Access Compliance Report Public Rights-of-Way (Curb Ramps)

Main Street: GARZA_AVE Cross Street: KATELLA_AVE Location: NE

ADA ID: RPRK210920133633 Ramp Type: Type 1 - Perpendicular Diagonal Initial Pass/Fail: Pass Overall Compliance: No Severity Score: 4

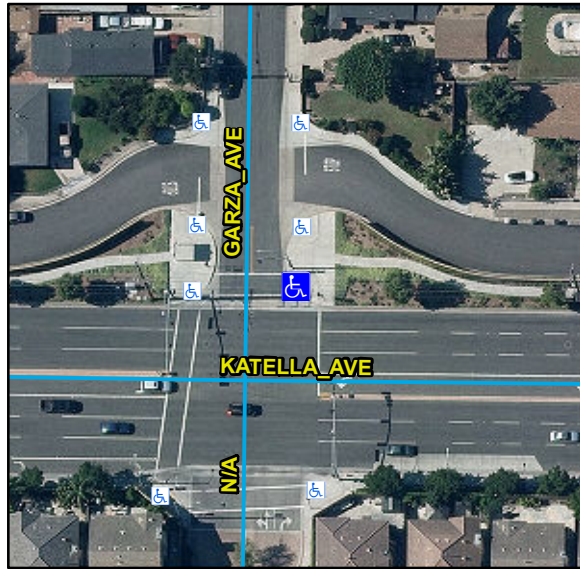
R304.2.1, R304.2.2-Perp, R304.3.2-Para, STD 1115

Remove & Replace Landing.
